EXPOSITION PARK BRANCH LINE RAIL TRANSIT CORRIDOR ROUTE

Final Environmental Impact Report

LOS ANGELES COUNTY
TRANSPORTATION COMMISSION

October 1992

FIGURE 3.3-2
NORTHERN SEGMENT
ALTERNATIVE 1b
Separate-Bridge

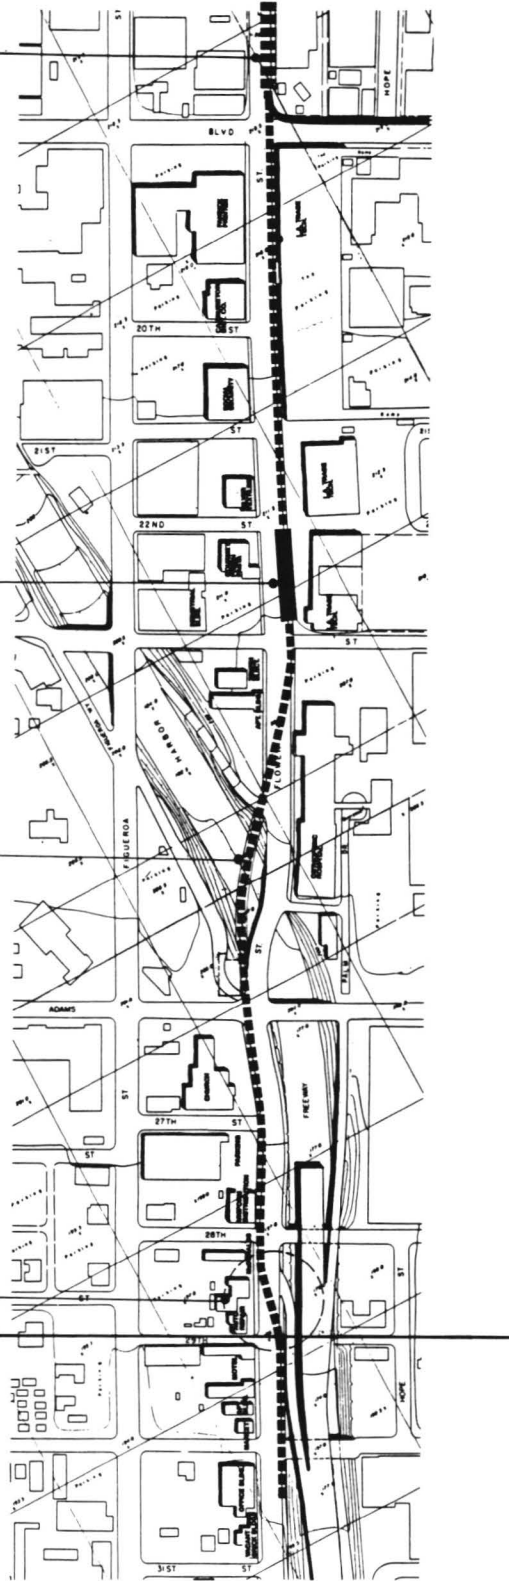
The hazard to autos is the same as for pedestrians. While there is confusion in the EIR as to where tracks in alternate 1b would cross Flower Street, Figure 3.3-2, wherever that crossing is in the Hospital's block, there would be continuous auto/train friction.

171. **Figure 3.3-2** is a summary map showing all of the alternatives under consideration. Each alternative is again presented in larger scale in Section 3.3, **Figures 3.3-1 to 3.3-5**.

FIGURE 5.3-3

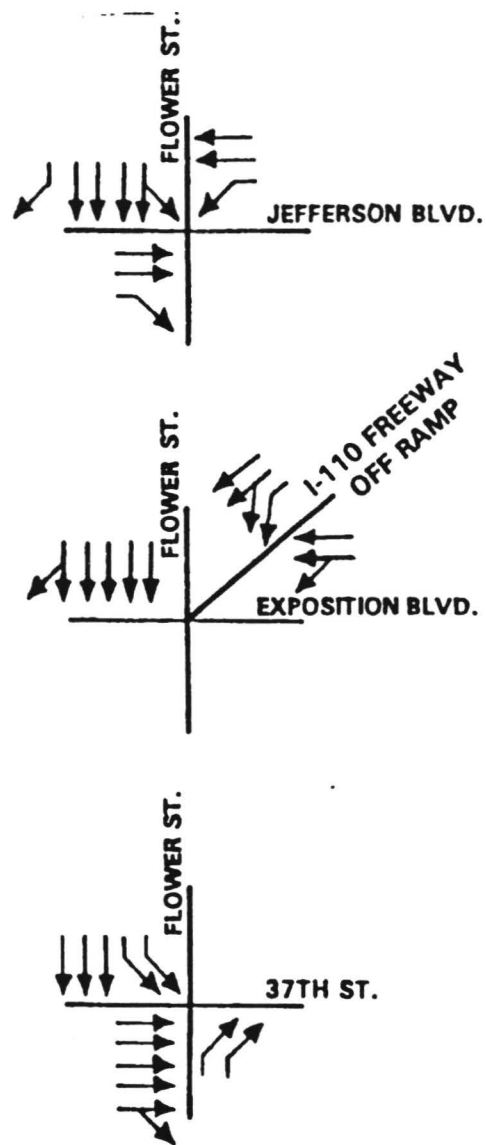
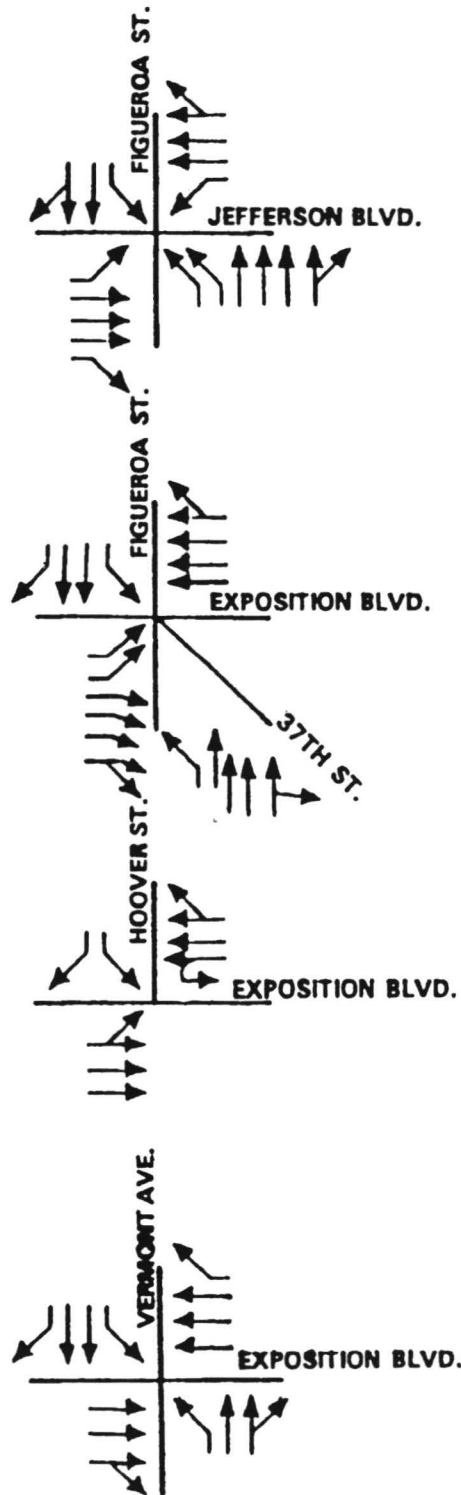
- o p 5-28: Figueroa Street - See earlier comments regarding two-way street operation. (69)
- o p 5-30: Fig. 5.3-3: Figueroa Street and Washington Boulevard for westbound show one right turn lane, three through lanes, and one left turn lane. (70)

- o p 5-30: Fig. 5.3-3: 23rd Street and Figueroa Street. For eastbound show on right turn lane, not two right turn lanes. (71)
- o p 5-30: Fig. 5.3-3: Adams Boulevard and Figueroa Street. For southbound show one right-turn lane, two through lanes, and one left-turn lane. For northbound show one left-turn lane, three through lanes and an optional through-right turn lane. (72)

- o p 5-30: Fig. 5.3-3: Flower Street and Washington Boulevard. For southbound show the left-turn lane as an optional left-turn through lane. For westbound show the optional left-turn through lane as a through lane; left-turns are prohibited. (73)

- o p 5-30: Fig. 5.3.3: 23rd Street and Flower Street for eastbound show the optional through-right lane as a right-turn lane. For northbound show a left-turn lane, in addition to a right turn lane. (74)

- o p 5-30: Fig. 5.3-3: Adams Boulevard and Flower Street. For southbound show two through lanes, not three. (75)
- o p 5-31: Fig. 5.3-4:
 - * Figueroa Street and Jefferson Boulevard: for northbound show a single left turn, not a double left turn. (76)

- 69. See Response #57.
- 70. The lane configurations reflected on **Figures 5.3-3 and 5-3.4** were based on the "Advanced Plan; Harbor Freeway (I-110) Transitway Figueroa Street - Flower Street 38th Street to 21st Street" provided to LACTC by LADOT at the outset of this EIR process, as well as existing geometrics along Washington Boulevard. The See Response #49.

FIGURE 5.5-2
PROXIMITY OF ORTHOPAEDIC HOSPITAL AND
APARTMENT BUILDING TO THE PROPOSED RAIL LINE

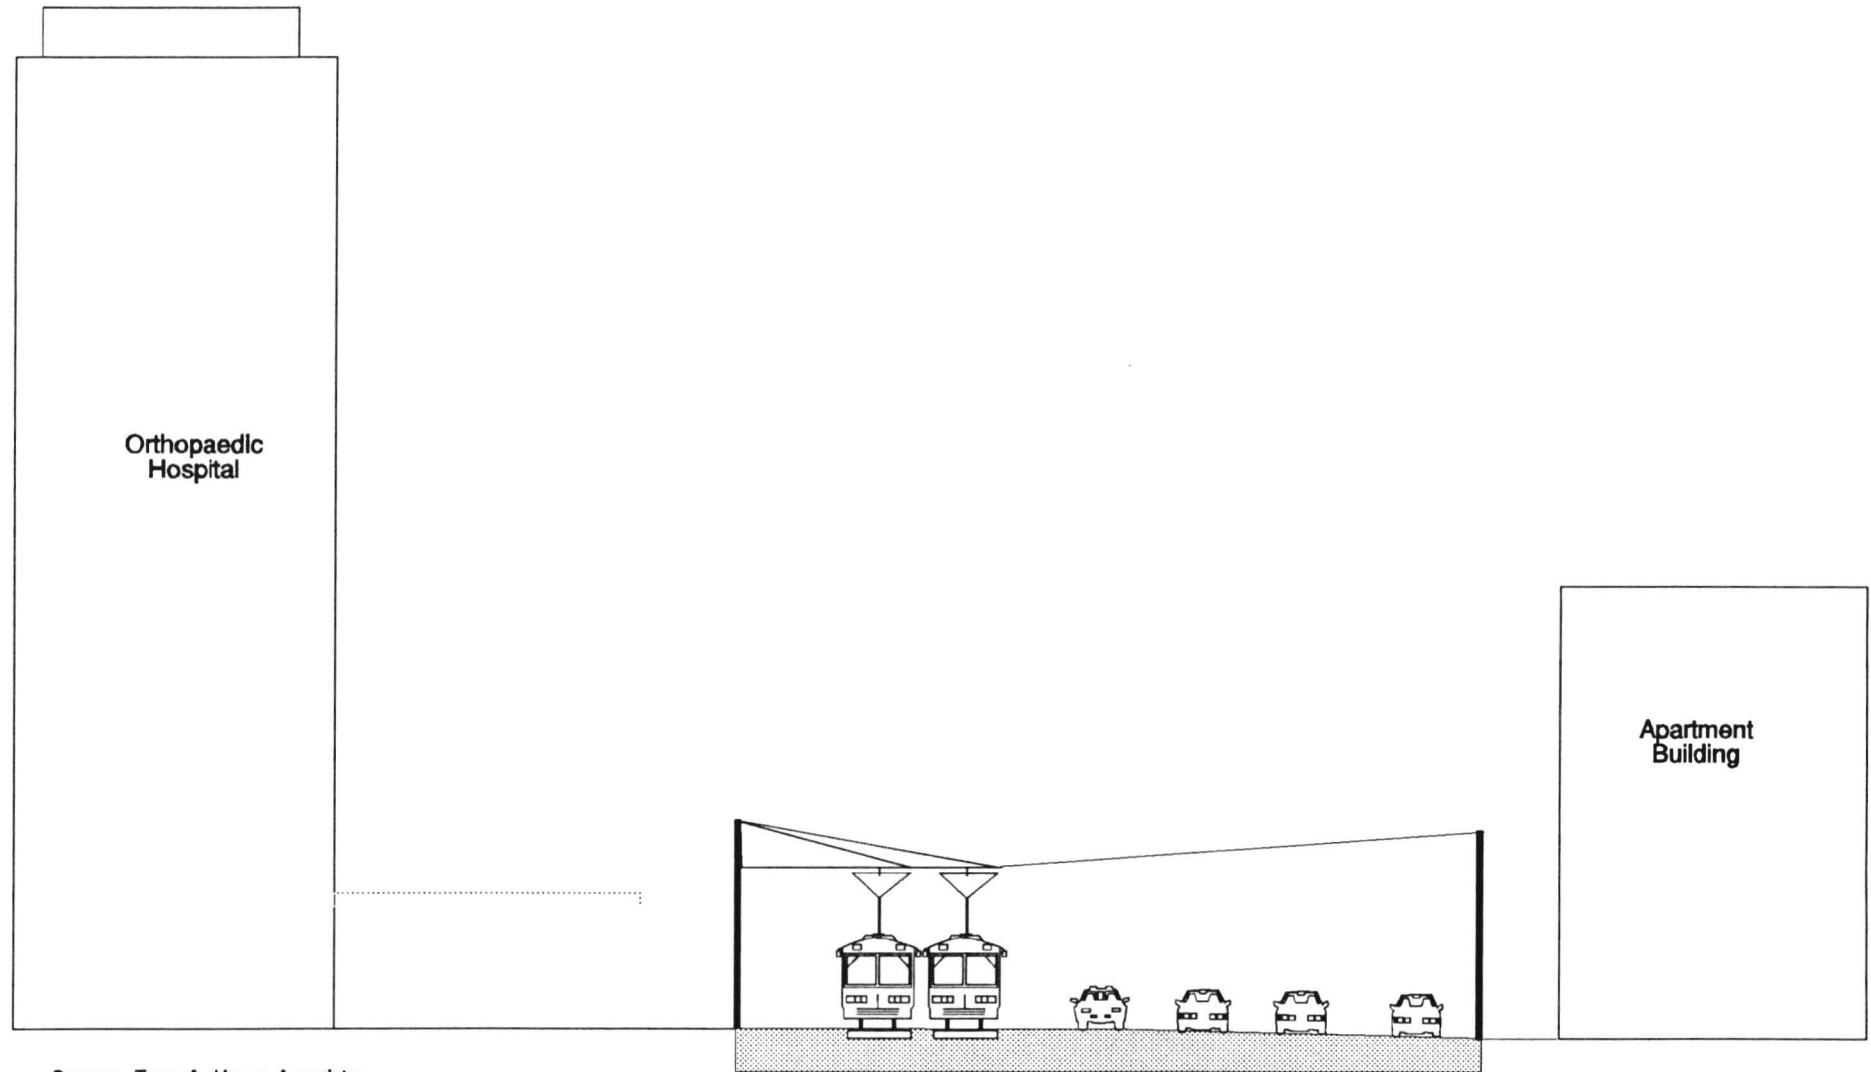
Typical cross-section (Figure 5.5-2) opposite Page 5-78 should be marked with the Flower Street widths and lane widths. Full analysis of the cross-section cannot be made unless existing widths and proposed widths are shown.

13. See Response #10.
14. **Figure 5.5-2** is intended to convey the general relationship of the rail line to the adjacent buildings for purposes of public presentation. This figure is a summary of detailed engineering cross sections that accompany the plan and profile for the alignment. The plan and profile sheets are scaled drawings that also show right-of-way widths. The plan and profile sheets are available for review at LACTC.
